SERVICE BULLETIN

Classification: EM09-007	Reference: NTB09-128	Date: November 16, 2009
-----------------------------	-------------------------	----------------------------

PATHFINDER / XTERRA / FRONTIER; BUZZING / WHINING NOISE FROM TIMING CHAIN AREA

APPLIED VEHICLES: 2005-2010 Pathfinder (R51) VQ40 engine ONLY
2005-2010 Xterra (N50)
2005-2010 Frontier (D40) VQ40 engine ONLY

Figure 1

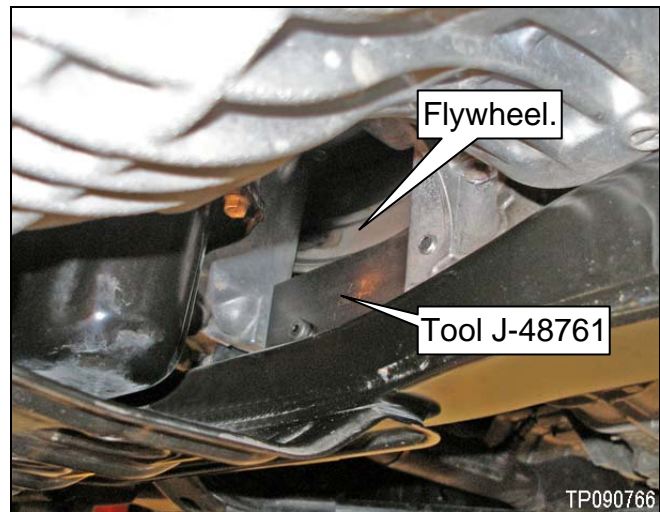
- Before removing the crankshaft pulley, set it to 0° Top Dead Center (TDC).
- Use Tool J-48761 to secure the flywheel / flex plate when removing the crankshaft pulley and camshaft sprockets. Figure 1 shows J-48761 installed on an AWD vehicle.

Figure 2

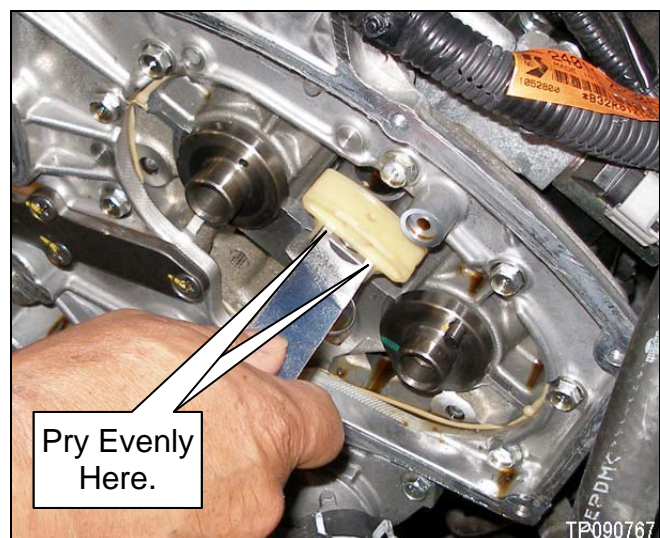
- Remove the Secondary Timing Chain Tensioner Shoes (shoe) by evenly prying with a couple pocket screwdrivers or suitable tool where shown in Figure 2.
